Attachment 1

Proposed Administrative Technical Specification Changes

Attachment 2

Proposed Changes to  
Technical Specification Pages

Figure 6.2-2 Facility Organization

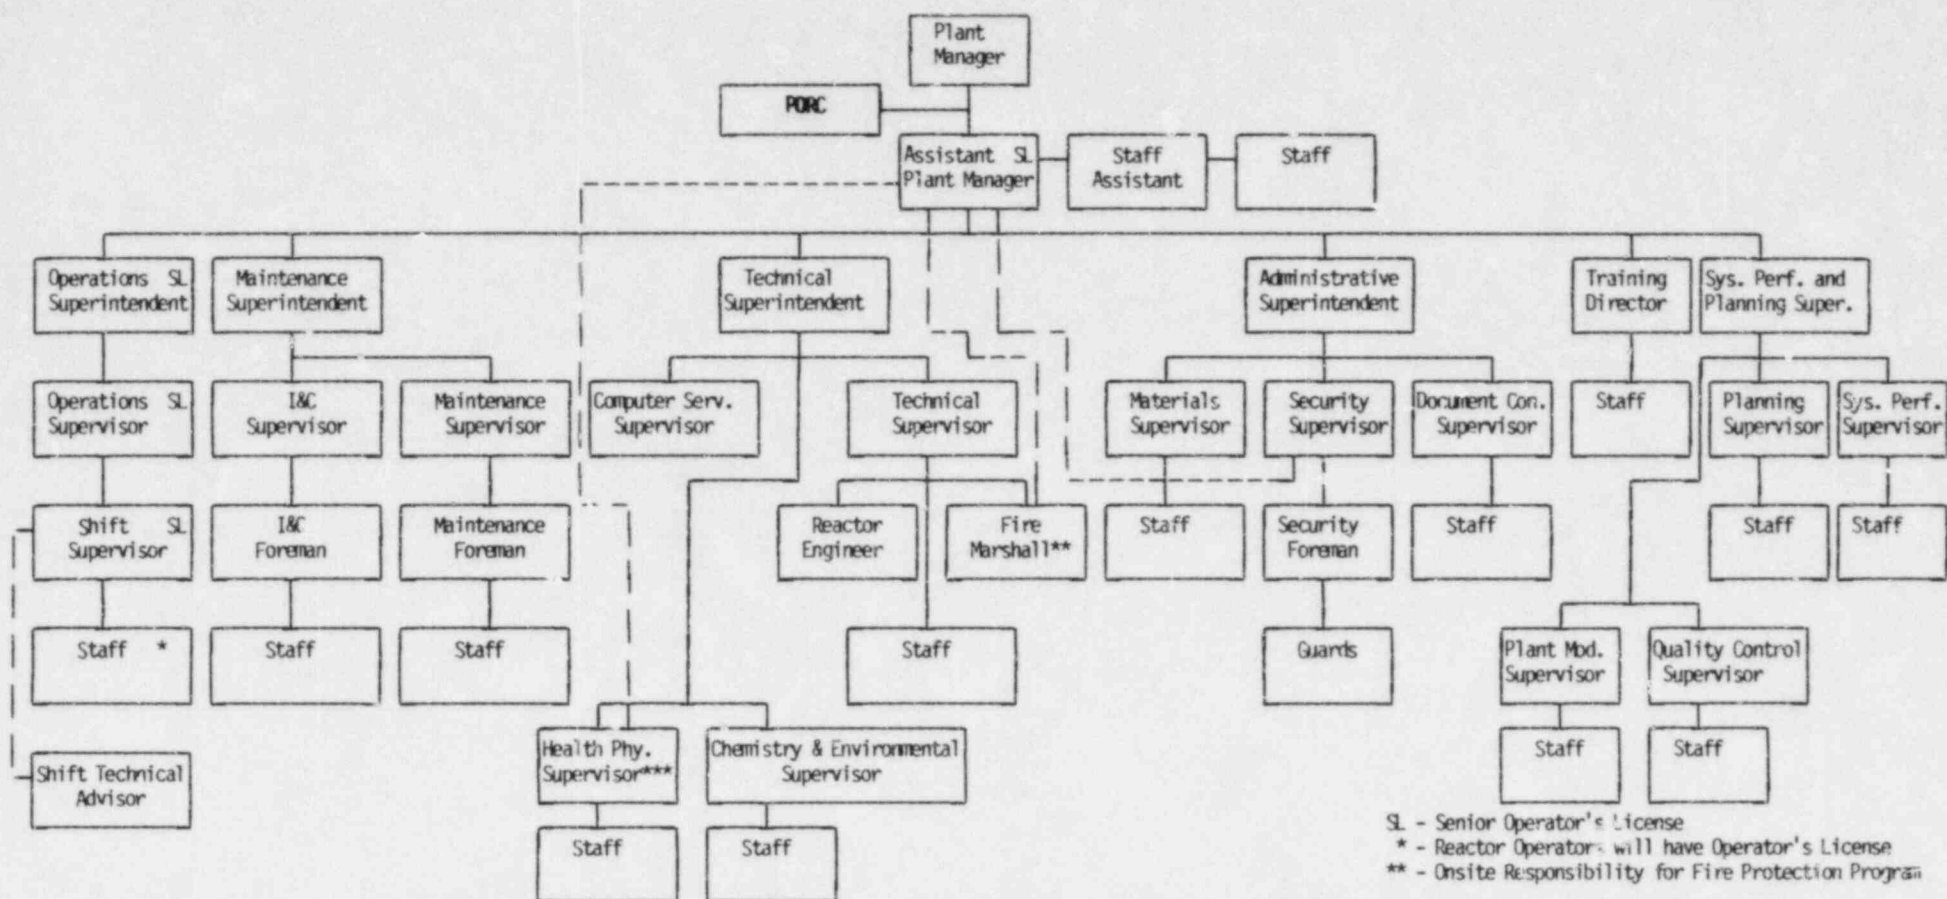
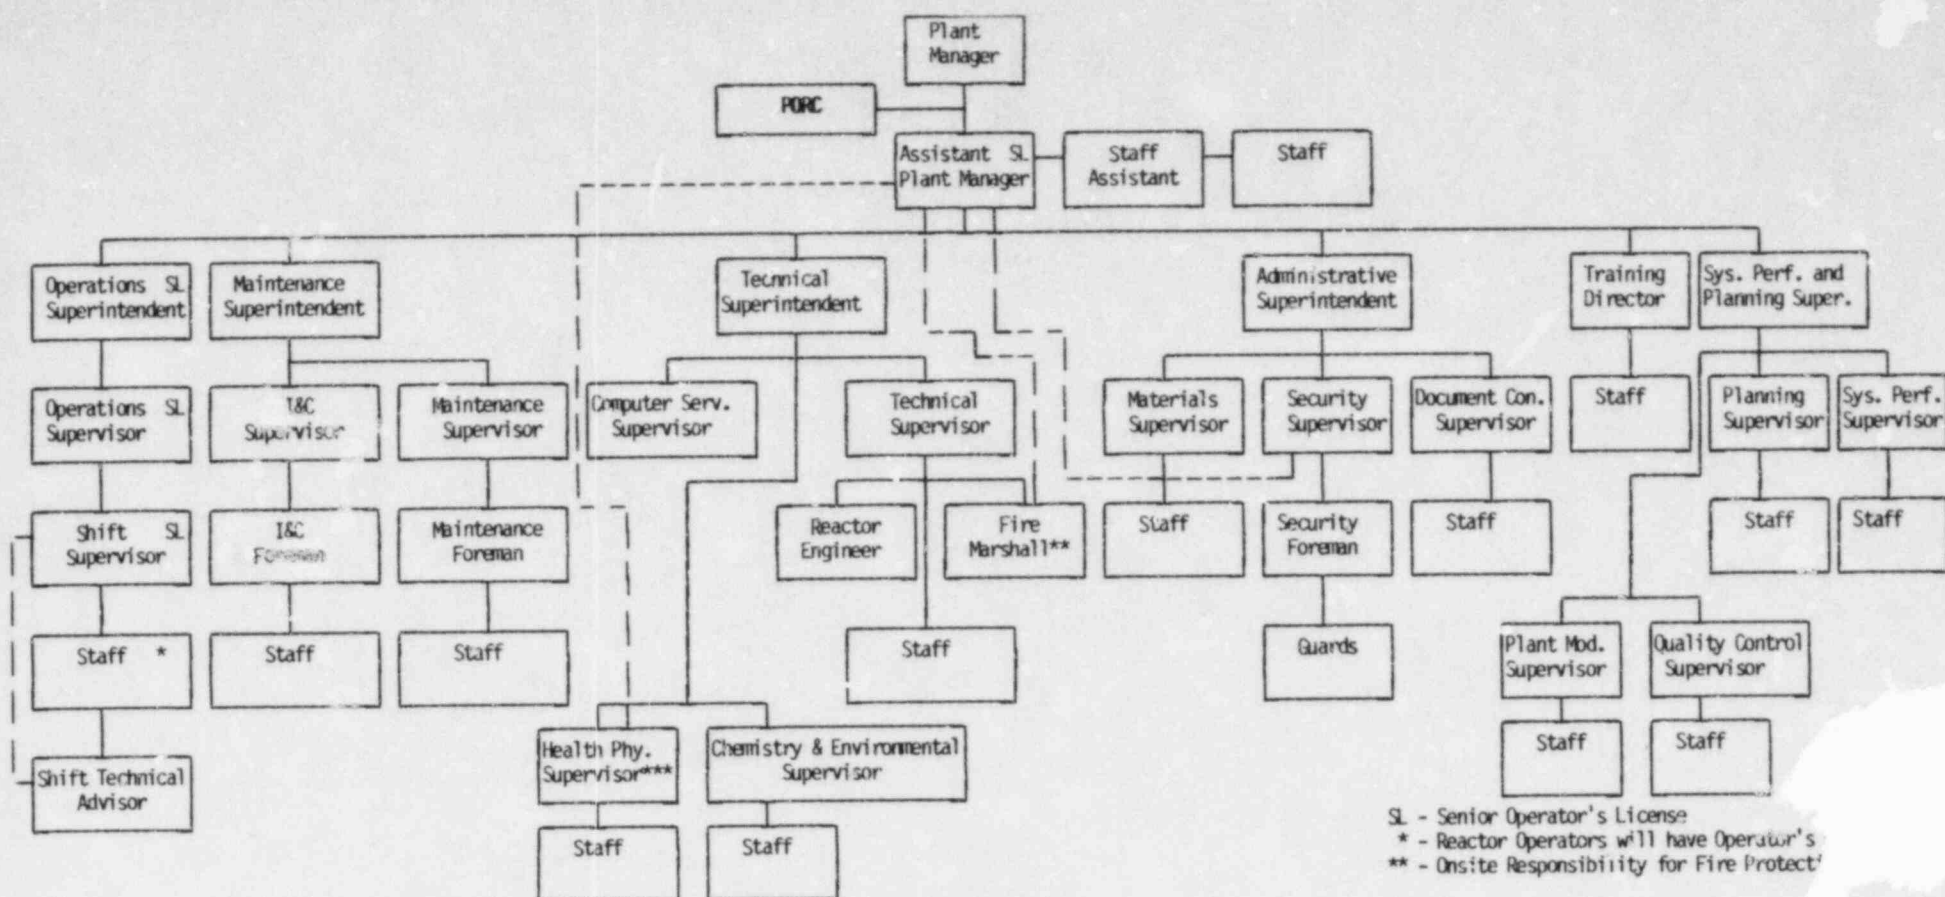
- 3) Change to Figure 6.2-2 (Both Units 1 & 2)

The Chemistry Supervisor Position title has been changed to Chemistry and Environmental Supervisor. There have not been significant responsibility changes as a result of this change. The change in title simply reflects more closely the responsibilities of this position.

In addition, the new position of Computer Services Supervisor has been added to Figure 6.2-2. This change reflects the importance of the Computer Services function in supporting the operation of the Farley Nuclear Plant.
